RE: REVISED-ENGINEER CERTIFICATION FOR FUSION, INC. (M15-D23D)
CERTIFICATION STATEMENT DATED 9/24/92.

RE: ENGINEER CERTIFICATION FOR FUSION, INC. (M-15/D23D) CERTIFICATION
STATEMENT DATED SEPTEMBER 7, 1992

RE: REVISED DRAINAGE PLAN FOR FUSION, INC. (M-15/D23D) ENGINEER'S STAMP WITH
REVISION DATE APRIL 3, 1992

RE: DRAINAGE PLAN FOR FUSION, INCORPORATED (M-15/D23D)
ENGINEER'S STAMP DATED DECEMBER 11, 1991

JOB Fusion, Inc.
SUBJECT Drainage
JOB NO. _____ SHEET 1 OF _____
BY MG DATE 12/20/91
CHECKED _____ DATE _____

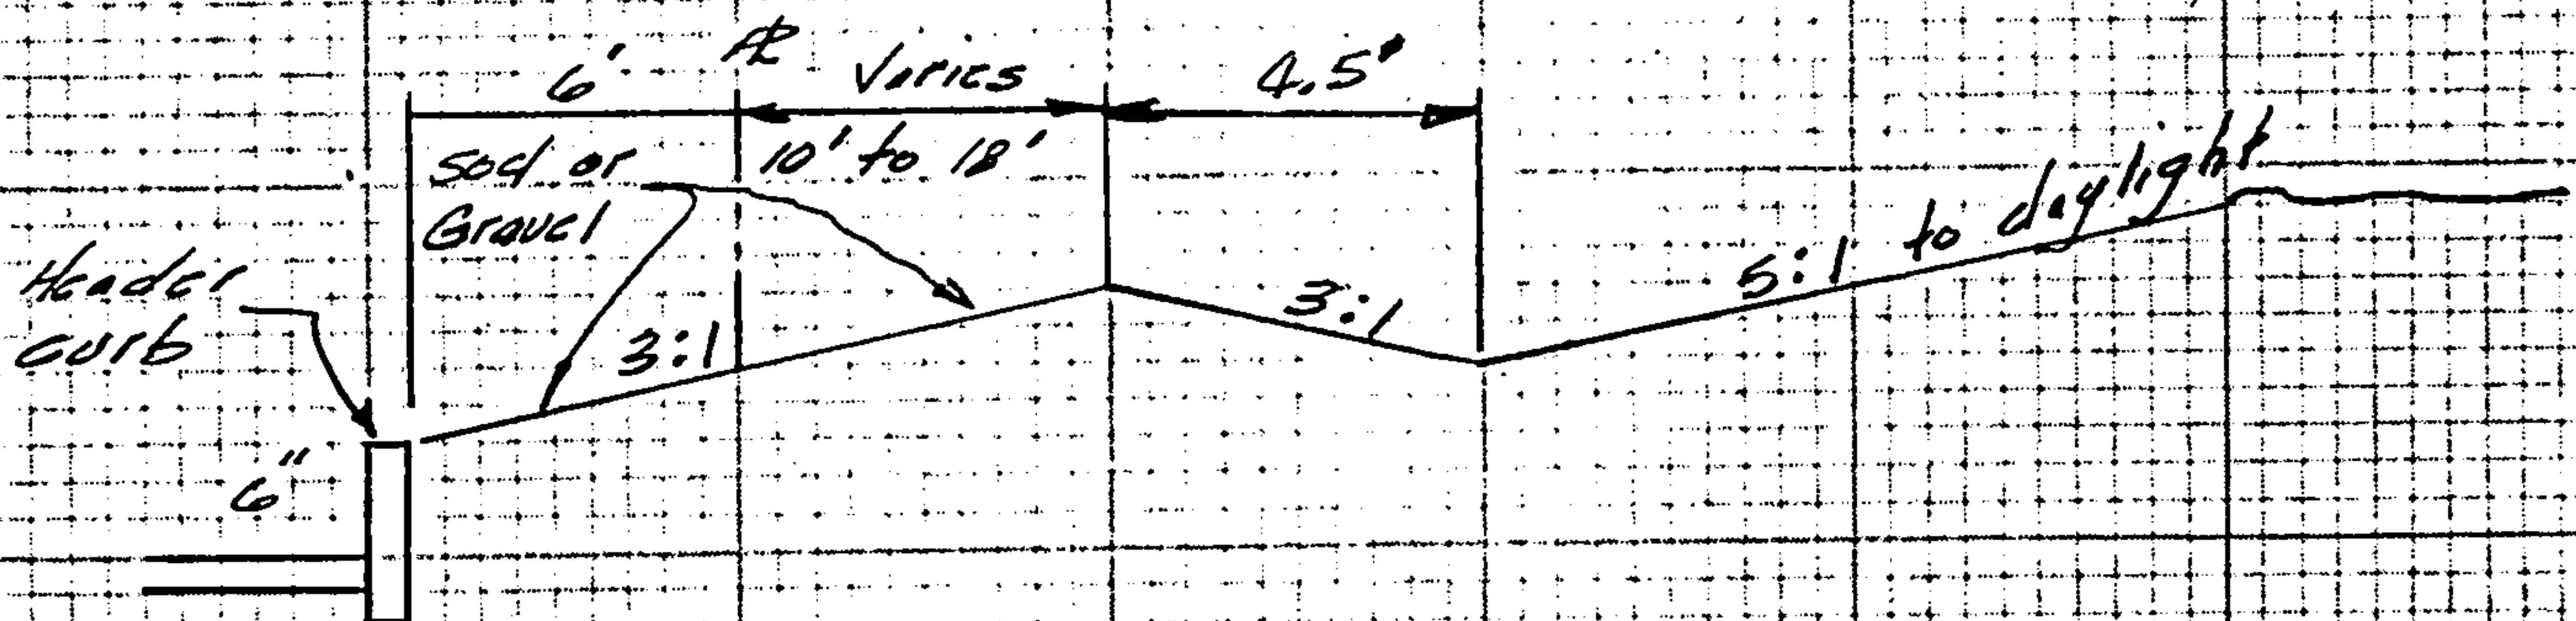
With owner permission, we are going to eliminate retaining wall and grade a swale on east side adjacent property:

$$Q_{REQ} = 17 \text{ cfs} \quad n = 0.040 \quad S = 0.5\%$$

$$Area_{MAX} = 9.50 \text{ Ft.} \quad WP = 11'$$

$$V = \frac{1.486}{.04} \left(\frac{9}{11} \right)^{2/3} (.005)^{1/2} = 2.30 \text{ fps}$$

$$Q = AV = 21 \text{ cfs} > 17 \quad \text{size 0.6.}$$

⇒ Since vel. of 2.30 is non-erosive ⇒ no lining

SHEET 3 OF 3

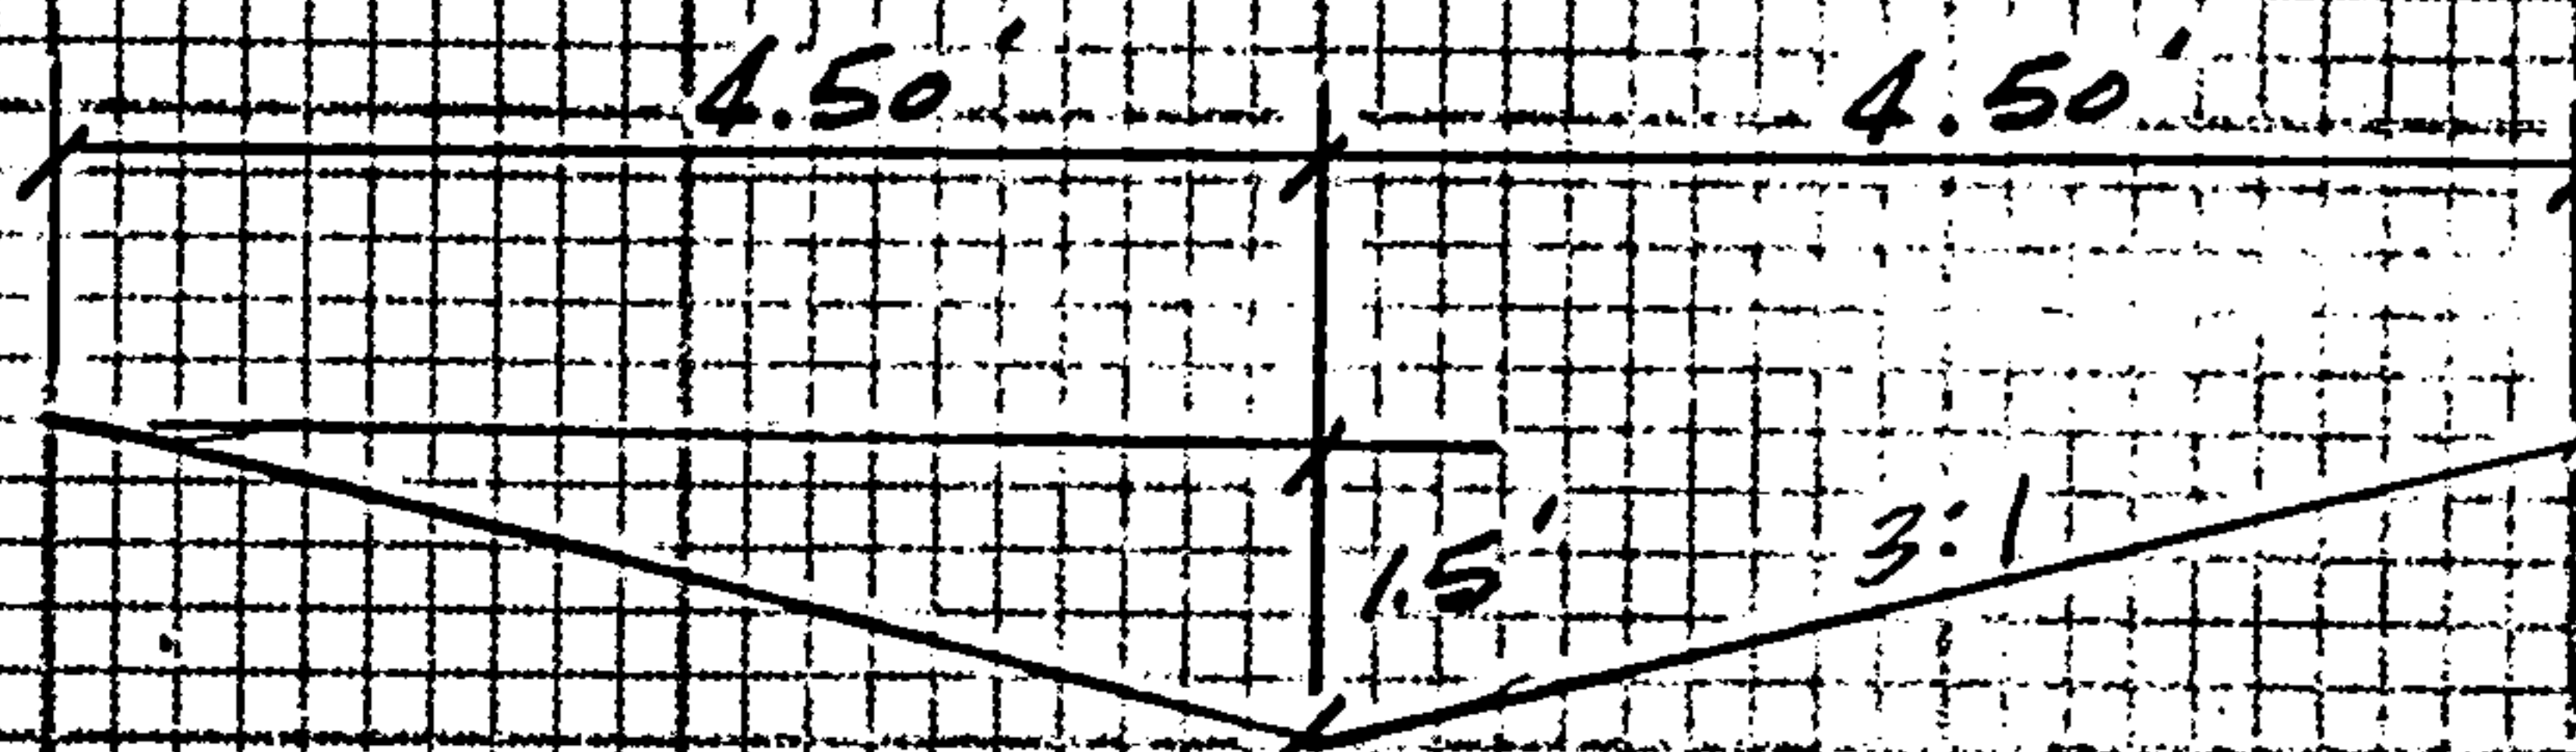
We need to size swale on west side
of sidewalk culverts for a $Q = 1.66 + 11 = 13$ cfs

$n = 0.025$ Landscaped $S = 0.015$ (Avg.)

Area = 6.75 sq. ft $WP = 9.49'$

$$V = \frac{1.486}{0.025} \left(\frac{6.75}{9.49} \right)^{2/3} (.015)^{1/2} = 5.80 \text{ fps}$$

$$Q(\text{max.}) = AV = 39 \text{ cfs} > 13 \text{ cfs} \checkmark$$

JOB Fusion Inc.
SUBJECT North Side Swale
JOB NO. _____ SHEET 1 OF 1
BY JMM DATE 4/2/92
CHECKED _____ DATE _____

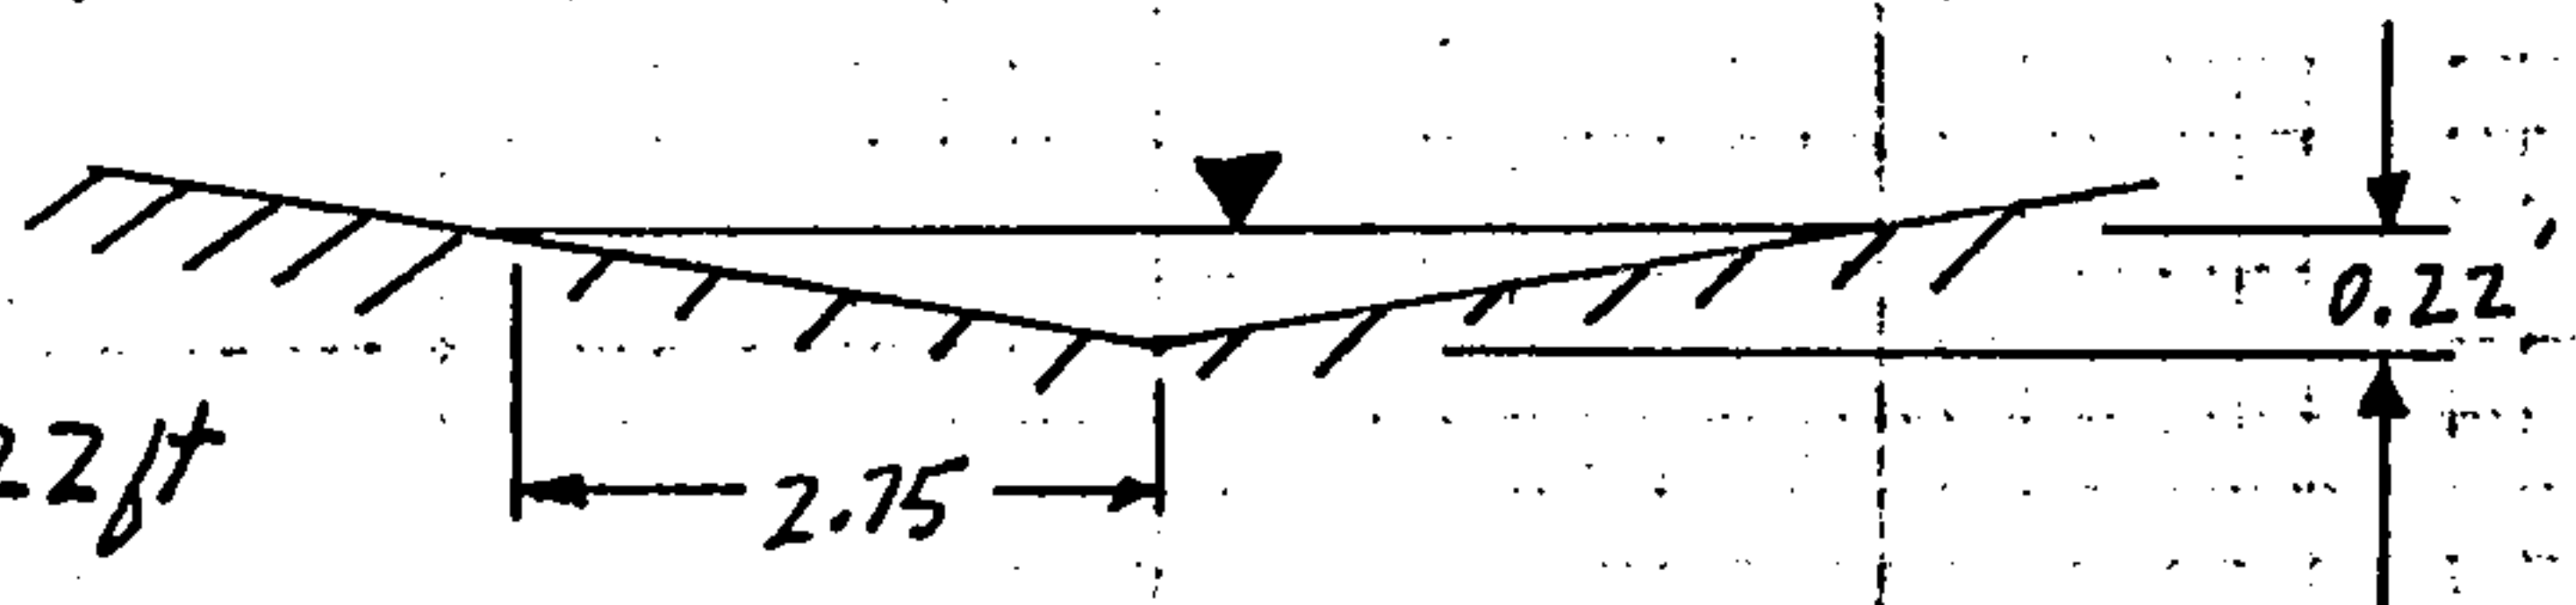
Evaluation of Channel Hydraulics for
Swale on North Side of Fusion Inc. Facility

Assume depth of flow $d = 0.22 \text{ ft}$

$$V = \frac{1.486}{n} (R_H)^{0.67} (S)^{0.5} = \frac{1.486}{0.025} (0.11)^{0.67} (0.031)^{0.5}$$

$$V = 2.39 \text{ fps}$$

$$Q = 1.44 \text{ cfs}$$
